Exhibit D17

Kwan, Roxanne S

Re: Approval to revise schedule for deliverables 6.3- Investigation and Remediation of Releases Report and 7.1.3. - Groundwater Flow Model Report of the Red Hill Administrative Order on Consent ("AOC") Statement of Work ("SOW") and Comments on Interim Environmental Reports

Conceptual Site Model Topics

Figure 10.3 Observed naphthalene concentrations following the 2014 Tank 5 release and a family of conceptual contaminant transport breakthrough curves matching those data. Other interpretations are viable, as is the possibility of LANPL contacting groundwater near RHMW02 following that release.

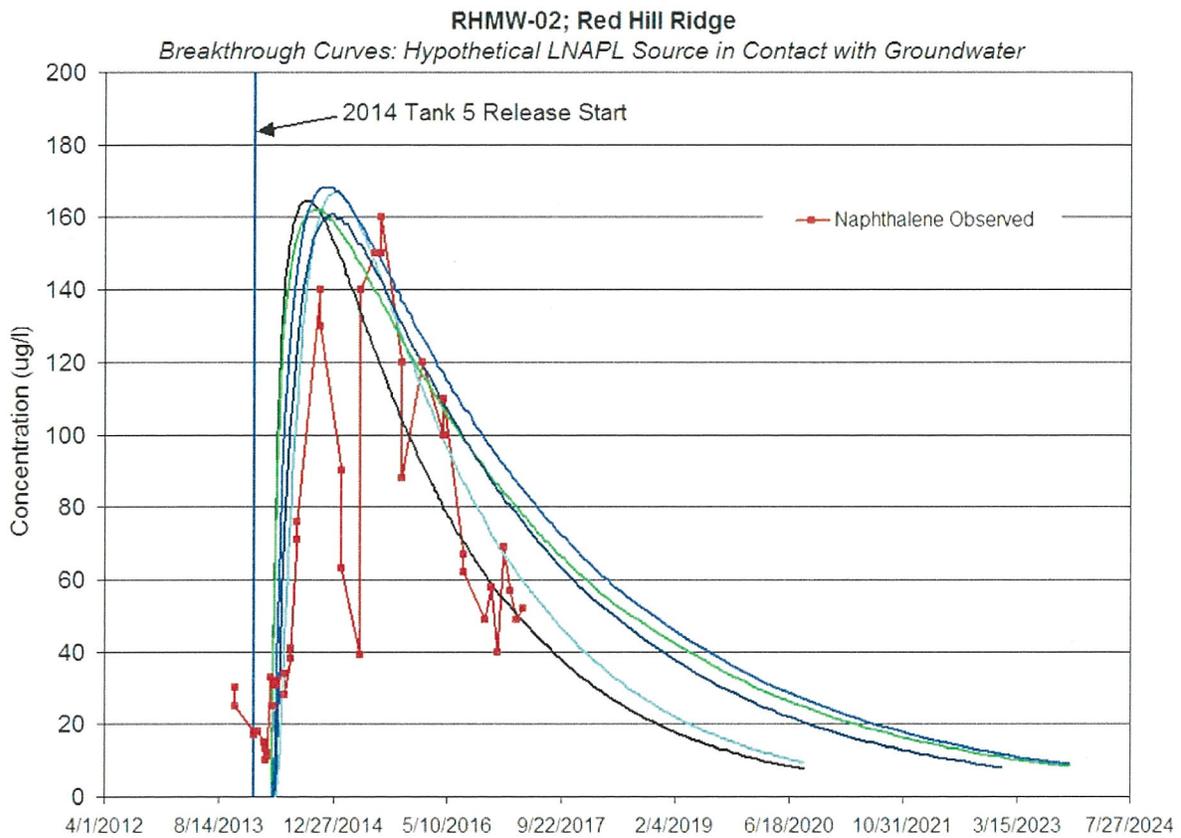
This alternate interpretation of LNAPL reaching the groundwater table following the 2014 release is consistent with site data and transport processes. The chemical analyte ratio methods used in the CSM to suggest otherwise are unbounded by site specific data of fuel compositional variability and analyte transformations. Further, we believe where chemical ratios use TPHd values, those values should also consider the native totals (without silica gel cleanup) because the parent hydrocarbons are predominantly derived from the original petroleum source(s). We also recognize the value of having both native and silica gel cleanup values for interpretation for various aspects of this investigation such as biodegradation and attenuation.

1. Strike and Dip

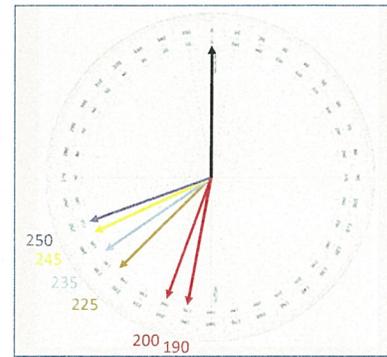
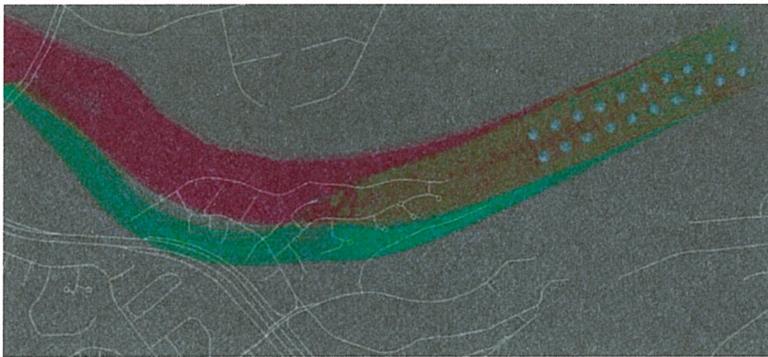
- Rudimentary tests - paths sensitive to assumed direction, magnitude
- Thorough testing or sensitivity analysis requires grid-realignment or full conductance tensor

2. Saprolite Extents

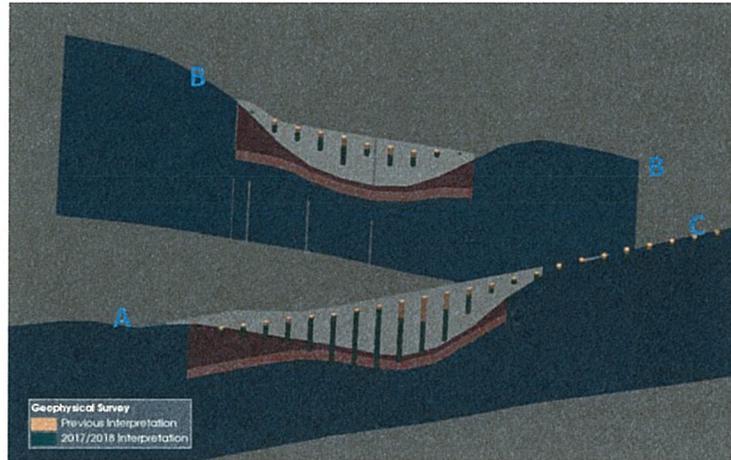
- Valley alluvium thickness
- Systematic pattern of modeled saprolite depth
- Early termination of longitudinal extents of saprolite
- Layer elevations based on prior interpretations may require revision to accurately represent conditions

2. Saprolite Extents

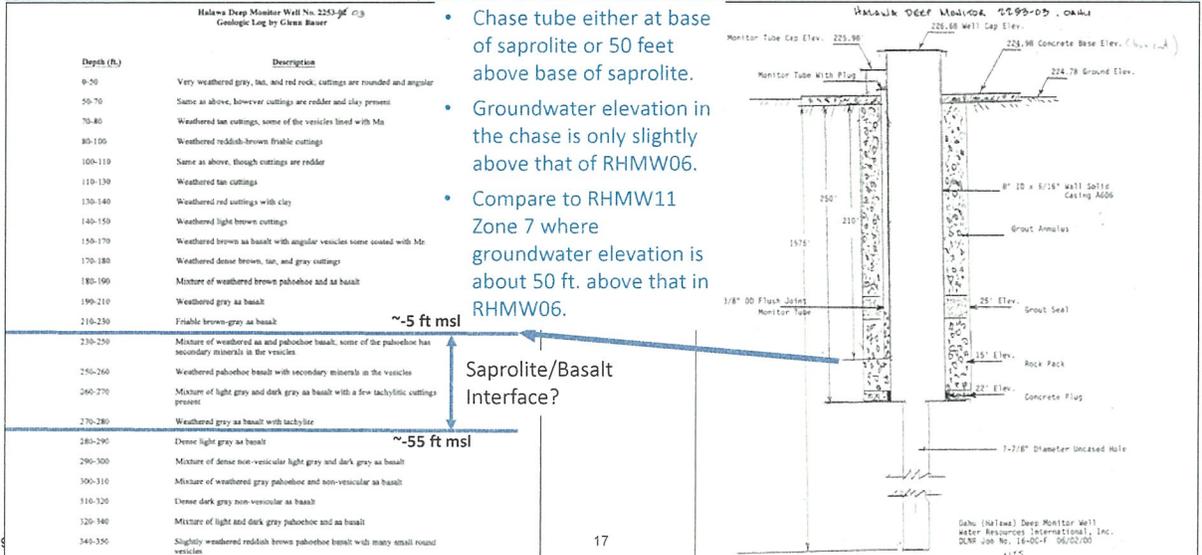
- HDMW2253-03 as Ground-truth
 - Can we definitively define the saprolite/basalt interface from available data?
 - Geo-logs
 - Well construction
 - Water level in the HDMW Chase Tube
 - Groundwater elevation vs. RHMW11 Zone 7

9. Groundwater Data

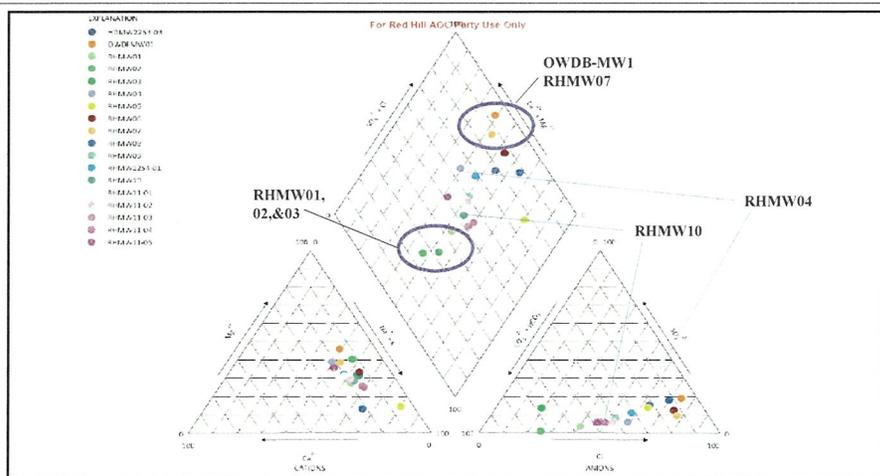
- Does the chemistry data show a flow path?
 - A potential mixing lines exists
 - However problems with spatial distribution
 - Possible more indicative of waters with contrasting chemistry

9. Groundwater Data

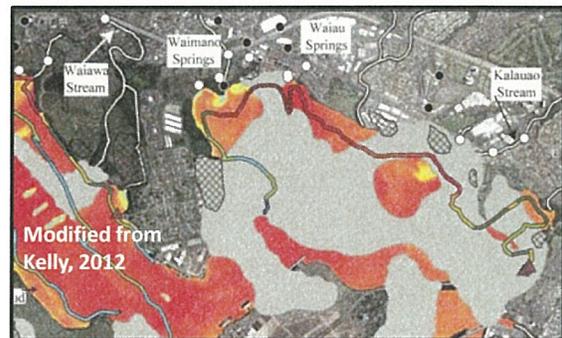
- Chloride conc. vary from ~40- >1000 mg/L
- Southeast very different from northwest
- Northwest chlorides still highly variable
- A large flux of groundwater down the Red Hill ridge should show better mixing
